July 20, 2021

RE: July 1, 2021, letter regarding Notice of Intent to File Complaint for Enforcement regarding OCS 024, 062, and 063. *PacifiCorp second response.*

Community Solar Project Interconnection  
**Community Solar Project System Impact Study Report**

Completed for  
**Sunthurst Energy, LLC**  
**(“Applicant”)**  
**OCS062**  
**Nye Solar**

Figure 2: Map of Proposed 12.5 kV Construction

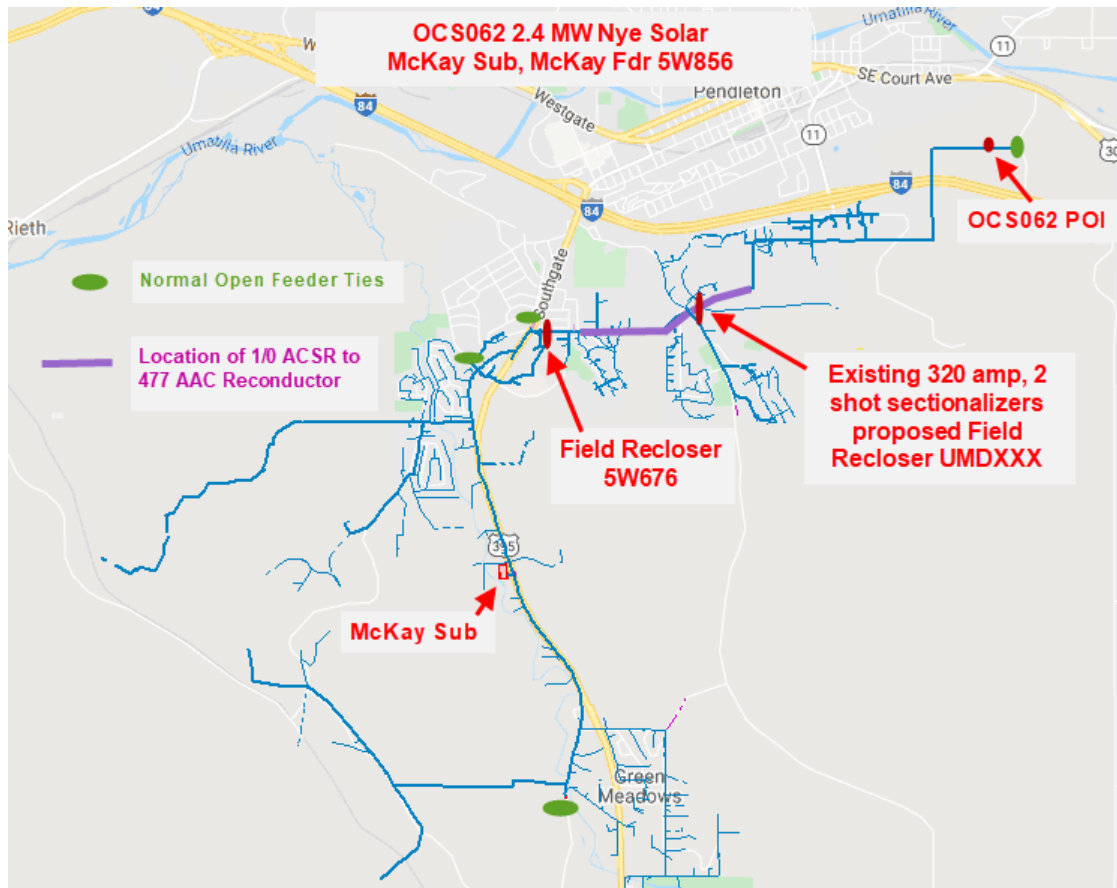
(4) Please provide the detailed analysis supporting its conclusion, in the OCS 062 SIS Report, that OCS 062 will require re-conductoring of 0.7 miles of distribution circuit. Specifically, the Report does not say whether the conclusion is based upon the Volt-VAR performance or whether this is a drop of generation due to fault. It also does not say whether Volt-VAR capabilities of the OCS 063 inverters can provide voltage regulation adequate to avoid re-conductoring.

- (5) IEEE 1547-2018 considers the number of occurrences per day as a criterion, not just the magnitude of the change. Requiring re-conductoring because there is one voltage change a month that exceeds the 3% recommendation (for example) is a misuse of the IEEE standard (which says that for events that happen less than 4 times per day, a 5-6% change in voltage is allowable). PacifiCorp documentation in its SIS Report does not establish that re-conductoring is warranted under the IEEE 1547-2018 standard.

Answer: The requested analysis was provided as a part of PacifiCorp's responses to Sunthurst's technical questions regarding OCS 062, which were provided by Mr. Ty Engle to Mr. Daniel Hale in an email dated July 2, 2021. PacifiCorp notes that the Volt-VAR

capabilities of OCS 063 does not impact the need for the reconductoring as it is due to a drop in generation.

Answer: As noted in response to Question 4 above, PacifiCorp provided an analysis to Sunthurst (via an email dated July 2, 2021 to Mr. Hale) substantiating the need for the reconductoring. Moreover, as explained in response to Question 2 above, PacifiCorp has removed the reference to IEEE 1547-2018.

Following are the distribution system upgrades required for the OCS062 project to be connected. Figure 2 below shows the general location of the required projects.

- To meet IEEE 1547 voltage fluctuation requirements an instantaneous generator output change from 100% to 0% must not produce more than a 3% change in voltage in any operating scenario. Studies show during peak load a generation output change from 100% to 0% results in a voltage change of up to 5.2 %. To correct this approximately 0.7 miles of three 1/0 ACSR primary and one #2 ACSR neutral conductors needs to be reconducted to three 477 AAC primary and neutral conductors from facility point 01102032.0150505 on SW 23<sup>rd</sup> St. north of SW Perkins Ave. east to facility point 01102032.0140702 located near latitude 45.656378°N, longitude 118.786757°W. After this reconductor it is projected the voltage change during peak loadings with a generation change from 100% to 0% output will result in a maximum 3.0% voltage change.
